IN THE MATTER of applications for resource consents by Gisborne District Council to upgrade the Waipaoa River Flood Control Scheme and construct a cycle way

STATEMENT OF SUPPLEMENTARY EVIDENCE: DAVID HENRY PEACOCK

FIGURE M1 - Types of Flood Damage

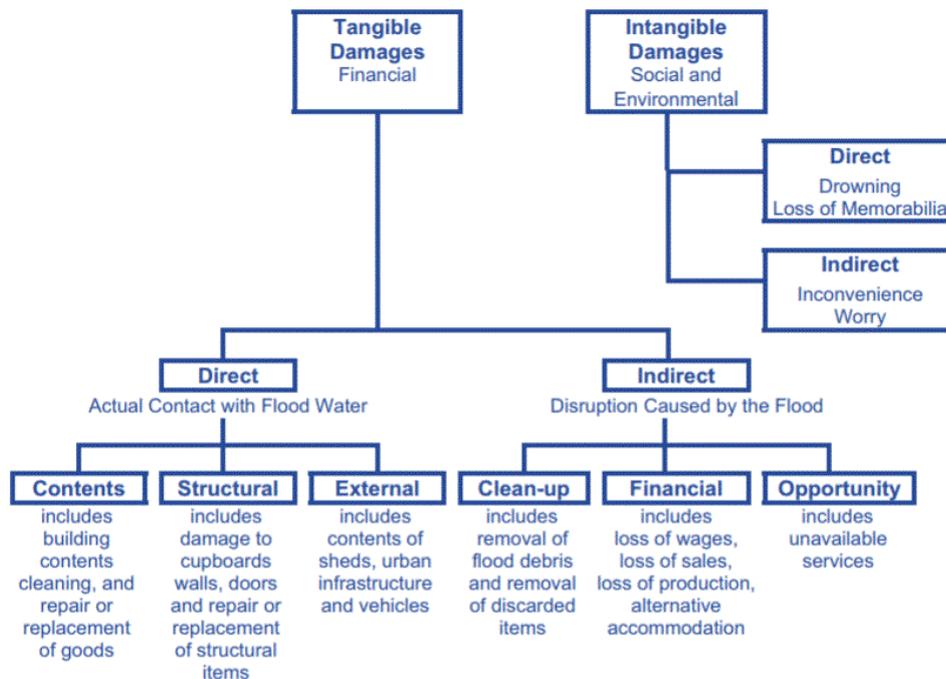
18. Most importantly however, the Riskscape curves do not show the large difference in flood losses for a flood peak which is centimetres below floor level compared to a flood peak which may be only centimetres above floor level. There are normally no damages for a flood peak just below floor level, whereas a flood only centimetres above floor level causes substantial damage. This is because water gets drawn up into the room linings and insulation (such as fibreglass batts), so that the lower wall linings have to be stripped to allow drying. Also carpets or floor mats will be saturated and impregnated with silty water, and have to be discarded. If the flood happens in the winter (as it often will) it will take weeks, if not months, to dry the floor and walls, so that the residents will be in emergency or alternative accommodation during this time. From past discussions with insurance companies, I understand that the tangible-direct flood losses to a typical timber framed house are in the order of \$30,000. Added to that are the tangible-indirect and intangible losses.
